Well Name: WERITO	Well Location: T23N / R9W / SEC 8 / NWSE / 36.1422 / -107.4833	County or Parish/State: SAN JUAN / NM
Well Number: 1	Type of Well: CONVENTIONAL GAS WELL	Allottee or Tribe Name: EASTERN NAVAJO
Lease Number: NOG5021714	Unit or CA Name:	Unit or CA Number:
US Well Number: 300453338200S2	Operator: DUGAN PRODUCTION CORPORATION

Subsequent Report

Type of Submission: Subsequent Report	Type of Action: Plug and Abandonment
Date Sundry Submitted: 02/26/2025	Time Sundry Submitted: 11:47
Date Operation Actually Began: 01/15/2025

Actual Procedure: Dugan Production P&A'd the well on 01/15/2025 - 01/22/2025 as per the attached procedure.

Werito #1

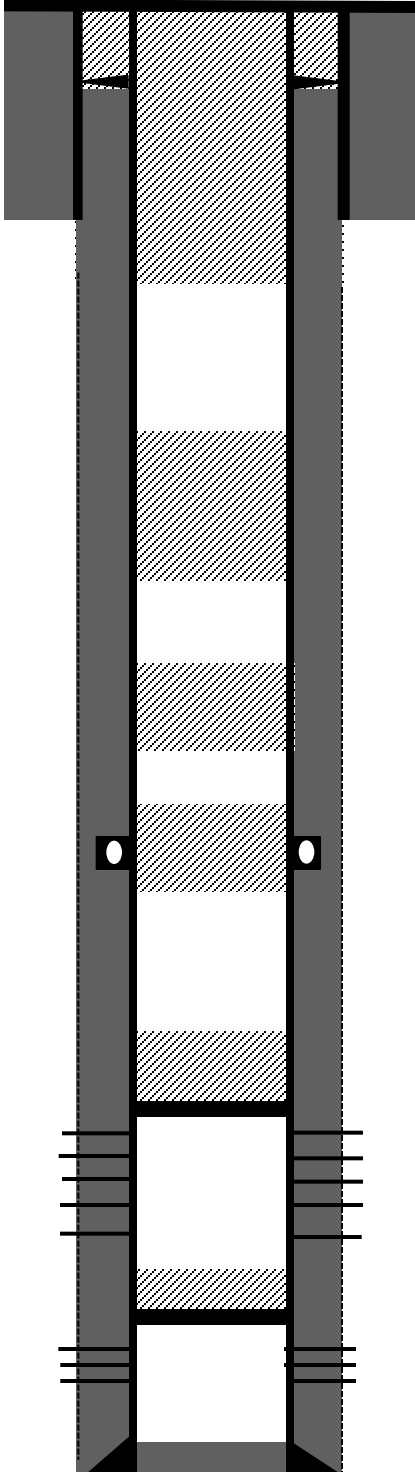
Plug V: Extend Plug V to add Upper Chacra top, Inside 4 ½" casing from 1366' to 567' (799', 71.5 Cu.ft Cement) to cover the Chacra Upper, Pictured Cliffs & Fruitland tops for Plug V.

On the approval for plugging I failed to see that the upper Chacra was not covered. Please add upper Chacra at 1316– I believe the BLM requests the lower Chacra

After running the CBL, the TOC behind the casing appear to be at 100' behind the casing. Based on the CBL we request the following changes to the originally approved NOI.

1. **Plug VI: Change from inside plug to inside/outside plug** - Perforate @ 90'. Attempt to break circulation to surface. RIH open ended to 426'. Fill up 4 ½" casing from 426' to surface. Circulate cement to surface through BH.
2. **Plug III: Add Chacra Lower Plug** - Extend Plug III, Mesaverde from 2096' to 1606' to cover the Chacra Lower Top per NMOCD requirement.
3. **Plug II: Mancos-DV tool** - DV tool was reported to be at 3700' from the original cement job log and was never reported. A copy of the document is attached. Extend Mancos Plug to 3750' to cover the DV tool.

NMOCD approves below

The BLM approves of the proposed changes to procedure.
